REVIEW OF THE DCPRA: Letter Report-04/Rev.1

A REVIEW OF SYSTEM ANALYSIS IN THE DCPRA:  
AUXILIARY SALTWATER SYSTEM

May 1989

Risk Evaluation Group  
Department of Nuclear Energy  
Brookhaven National Laboratory  
Upton, NY 11973

Figure 2.3. Logic diagram for top event, AS and initiator, LOSW.

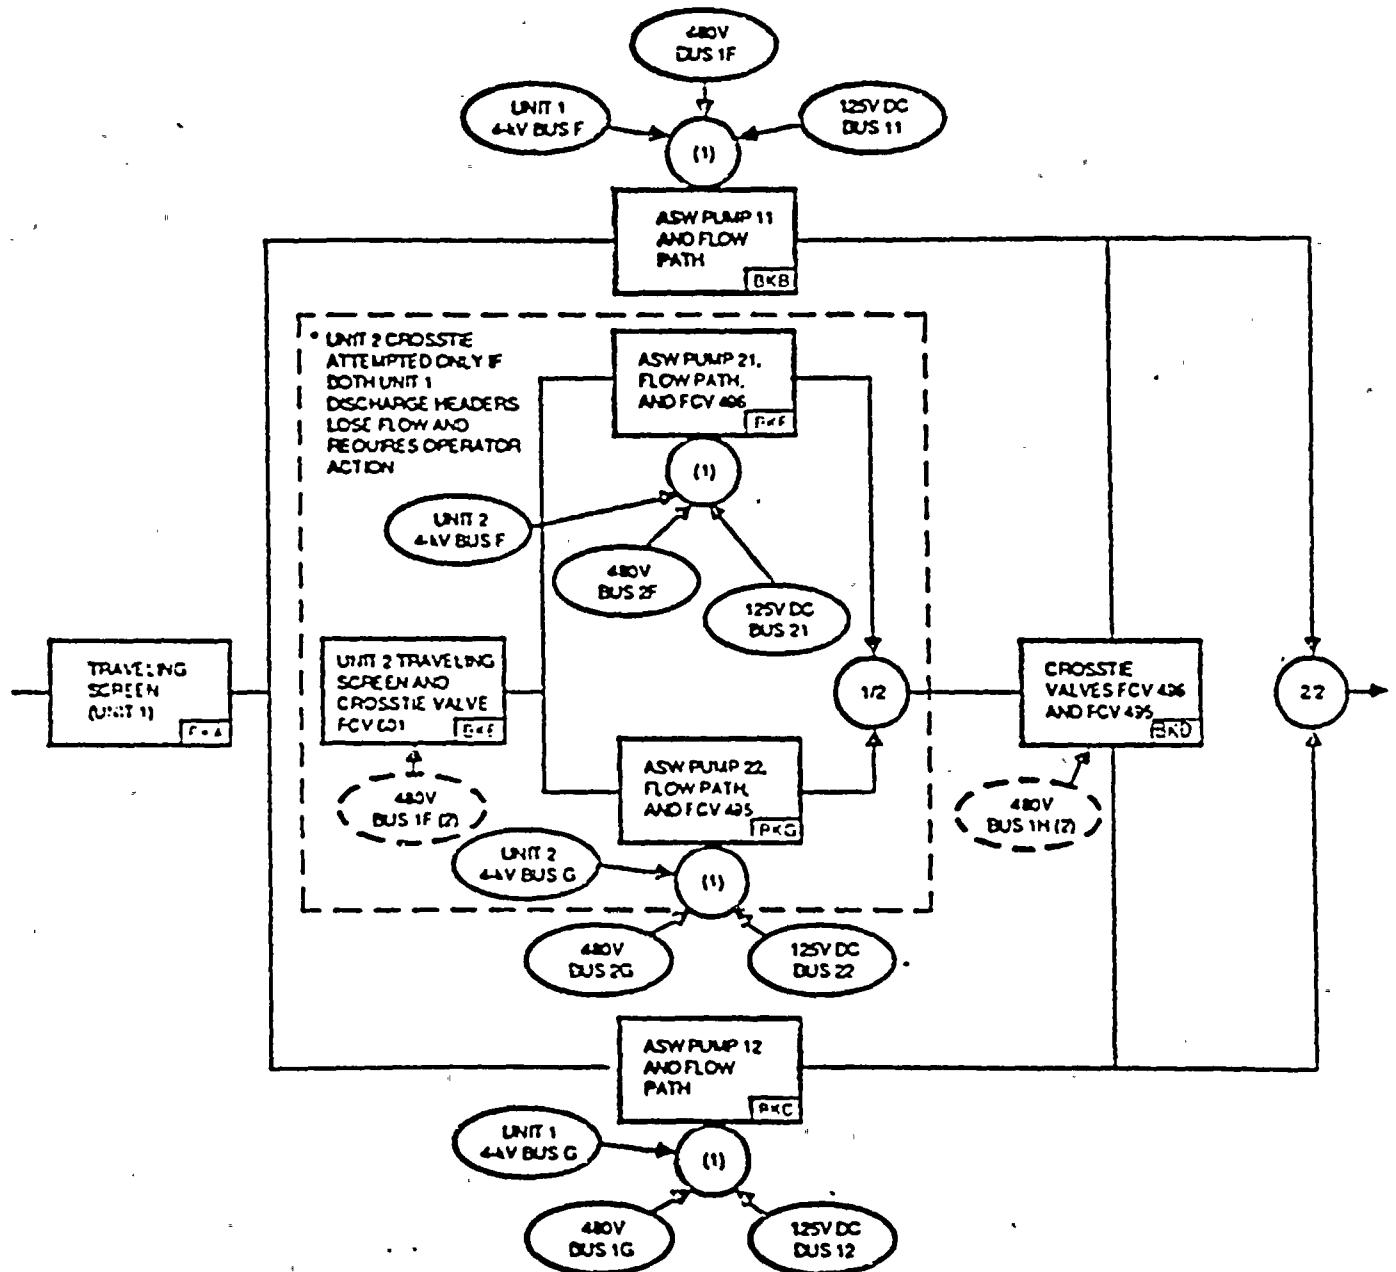
The review found that the DCPRA unavailability model of the ASW system only weakly reflects the industry-wide proneness of an SW train to be randomly blocked or to be prevented from functioning properly (e.g., by leaking) because of the environmental effects prevalent in such a system. Specific observations include:

1. Consider, e.g., the failure mode "Failure of the traveling screens, (ZTSC3P, plugging)." This is a common cause failure in the ASW unavailability model which one can take to be representative of some environmental effects. It was assumed in the DCPRA that this failure mode fails both trains at Unit 1 or both trains at Unit 2 but was not considered as a common mode failure for both units taken together. In other words, the cut set for common mode failure of the traveling screens for both units would be the Unit 1 common mode failure ANDED with the Unit 2 common mode failure. Even so, the DCPRA analysis identified it to be a leading contributor to the ASW systems' unavailability.

In the initiator model, however, this failure mode was not included for Unit 1, on the basis that complete recovery was assumed. As was mentioned in Section 3.2, experience indeed gives some indication that these types of failures can be recovered (similar to loss of offsite power initiators). To neglect them completely, however, seems to be somewhat optimistic.
